SERVICE INFORMATION

LAND-ROVER PETROL AND DIESEL MODELS

The Rover Company Limited, Solihull,
Warwickshire, England

May 1972

Fig. 1 Steering column lock (petrol type illustrated)

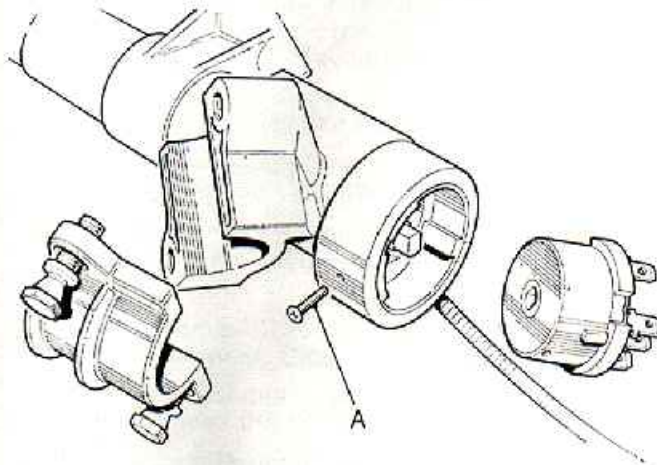
A number of complete steering column lock assemblies have been returned under warranty when only the ignition and lock switch on petrol models (heater and lock switch on diesel models) was known to be faulty. It is emphasised that the switch unit can be replaced separately from the main assembly. However, to gain access to the switch it will be necessary to remove the steering column lock first.

1. Disconnect the battery earth lead.
2. Disconnect the cold start control or engine stop control as applicable, in the engine compartment.
3. Remove the fixings and withdraw the steering column upper shroud.
4. Remove the fixings and move aside the lower shroud.
5. Centre punch and drill a hole in each sheared bolt to accept an extractor.
6. Remove the sheared bolts, using a suitable 'Easy-out' extractor.
7. Withdraw the steering column lock and retainer saddle.
8. Disconnect the electrical leads at the switch.
9. On petrol models, remove the single 'Posidrive' screw which retains the ignition and lock switch, as illustrated. The larger heater and lock switch used on diesel models is held by two 'Posidrive' screws. Both types of switch unit are provided with a keyway to ensure correct location on replacement.

Any warranty claims for replacement of a complete steering column lock assembly when only the switch is faulty will be disallowed.
